INTERNATIONAL ASSOCIATION OF CLASSIFICATION SOCIETIES LTD.

June 2023

History Files (HF) and Technical Background (TB) documents for URs concerning Mooring and Anchoring (UR A)

Figure 1
Example of Power Distribution System and Requirements for 'Icu' or 'Ics'

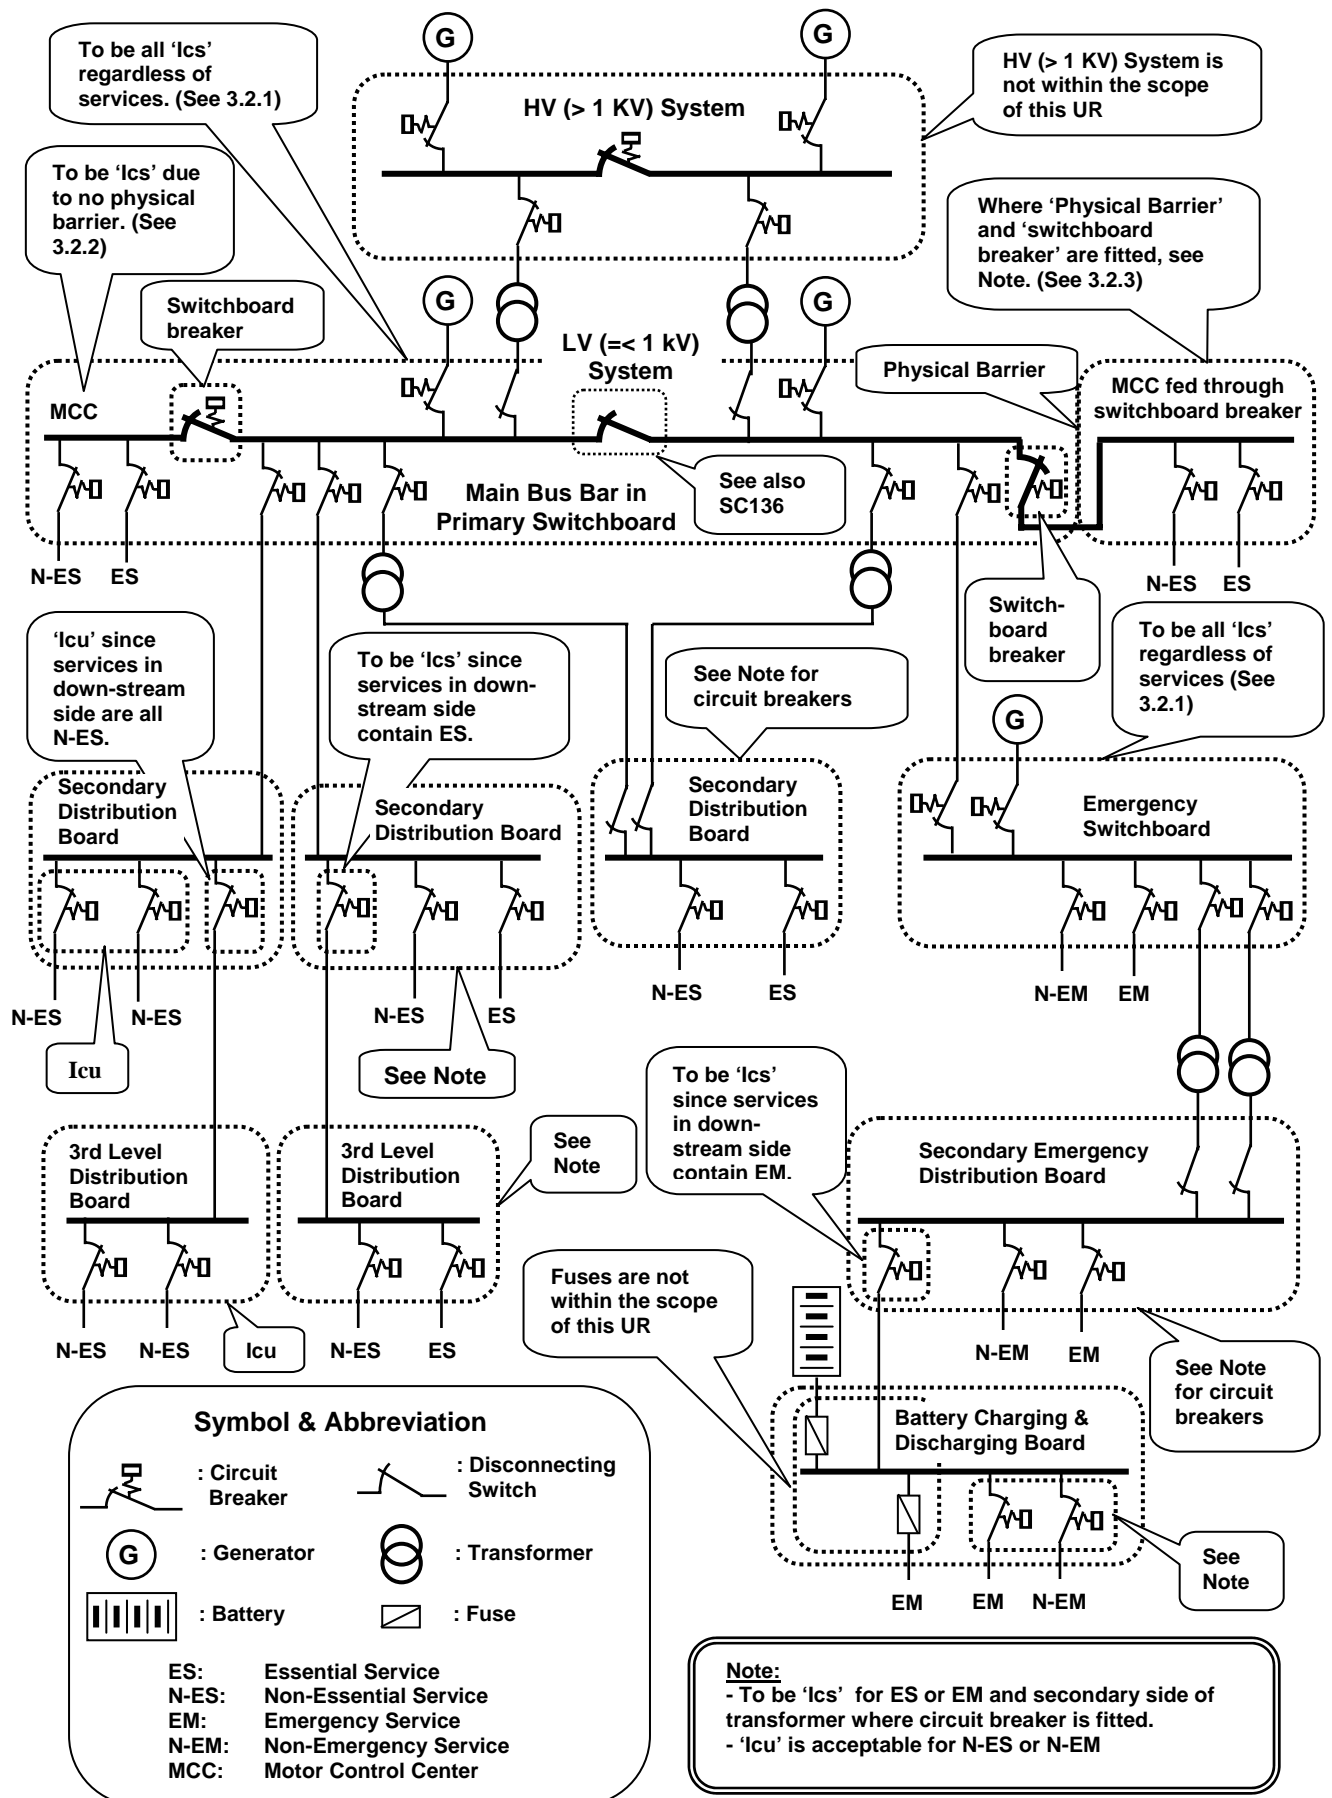
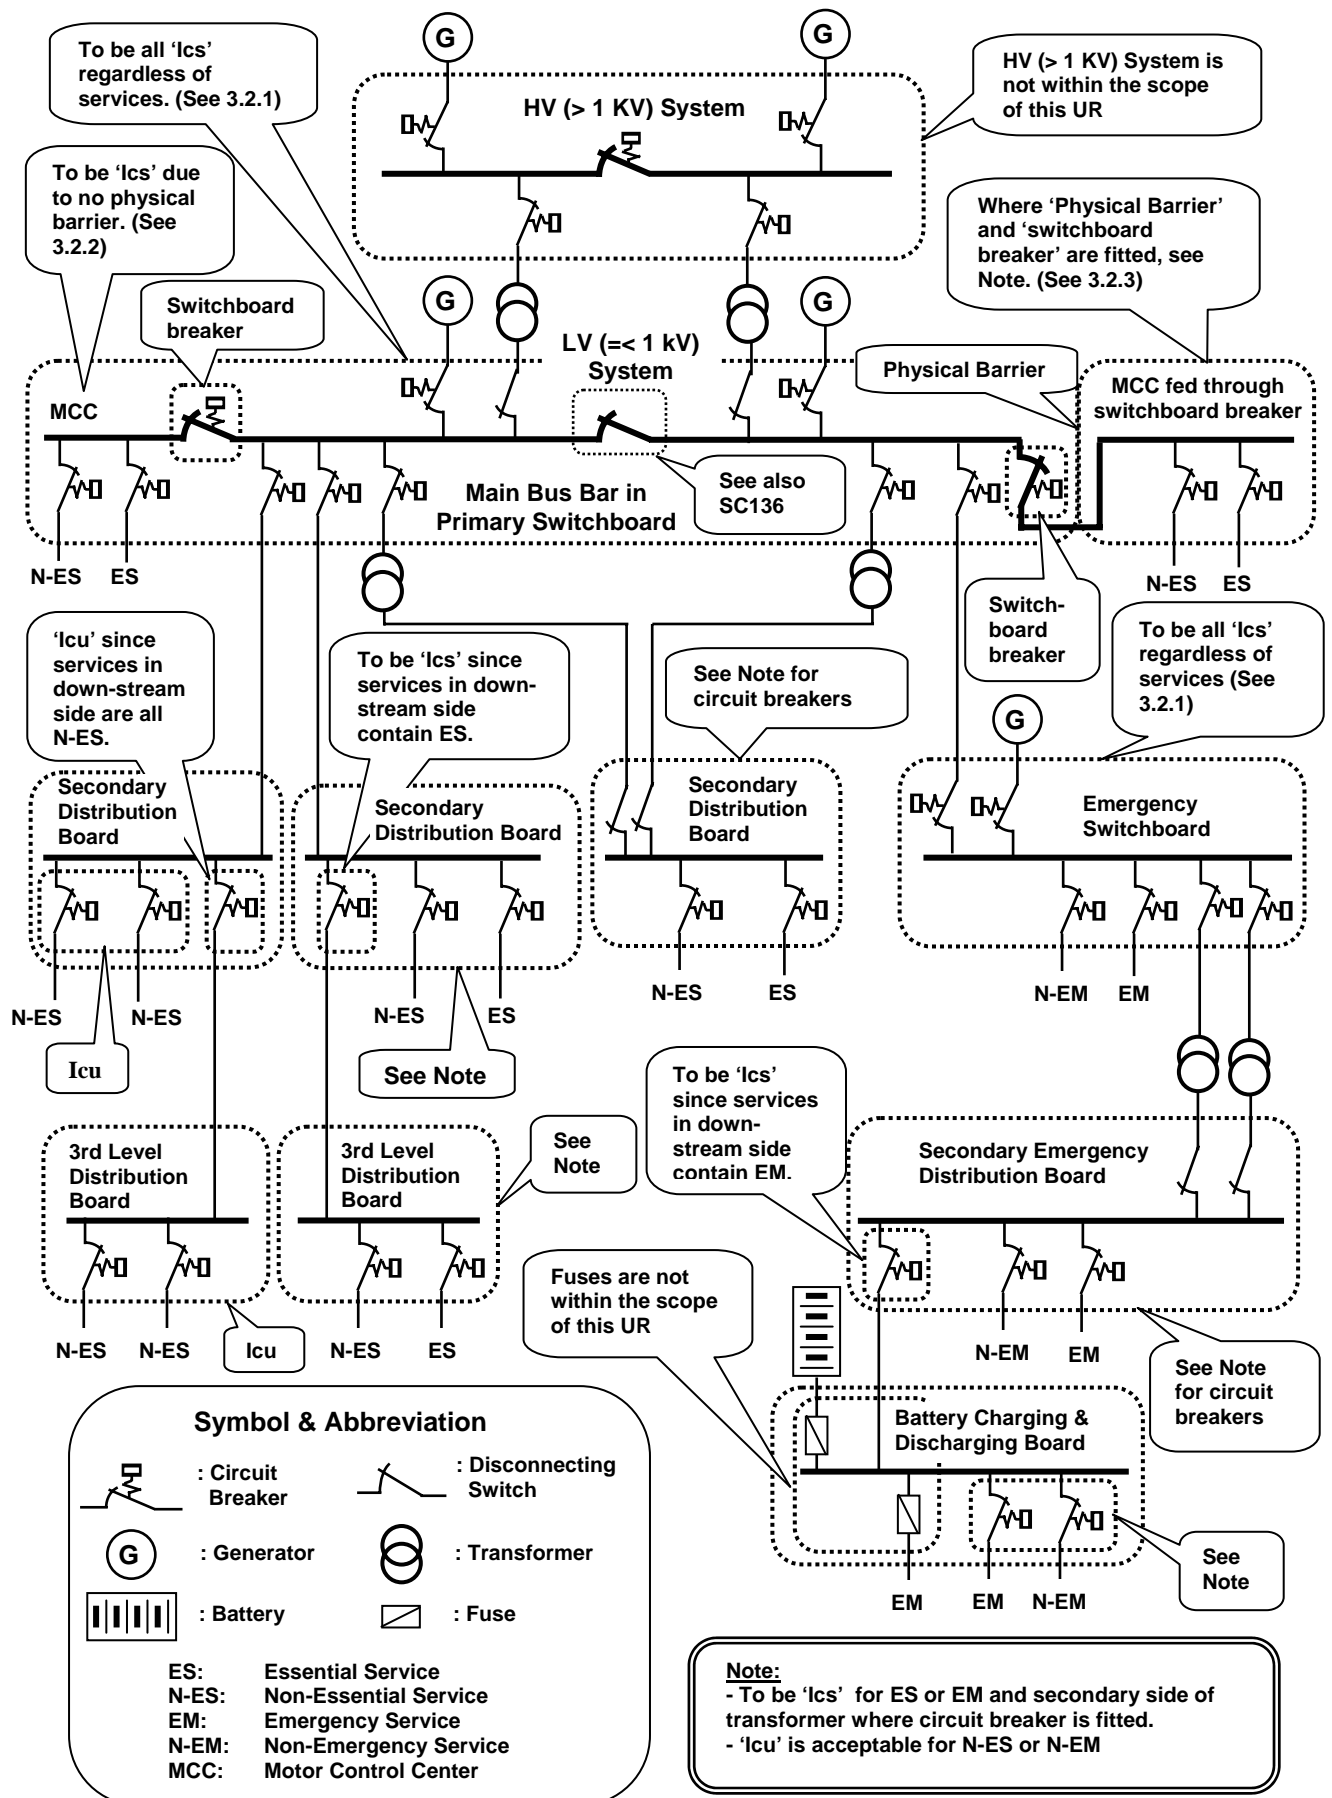
1. A GPG Member commented that in Figure 1 of the UR, the style of the lines connecting ESB with DB, DB with DB, and DB with "Electrical consumers" should be changed into the dashed line indicating "Flame retardant cable". MCH Panel Chairman confirmed that was what the Machinery Panel had intended. Hence, this proposal was accepted.
